SUBJECT : HASRPER CO., LTD. FCC ID: O5XHP-420B FCC Part 15 Subpart B Certification

FCC ID : O5XHP-420B Model : HP-4200B

• ITEM of ADDITION

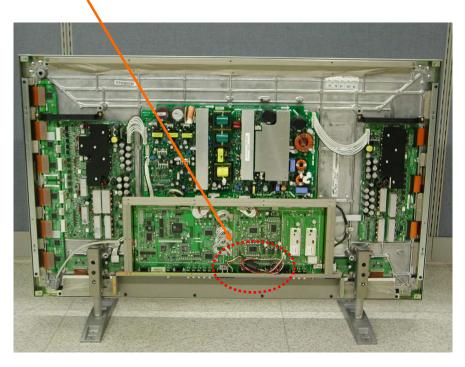
1. Apply a ferrite Core to the Main Board

2. Attach a gasket on the panel
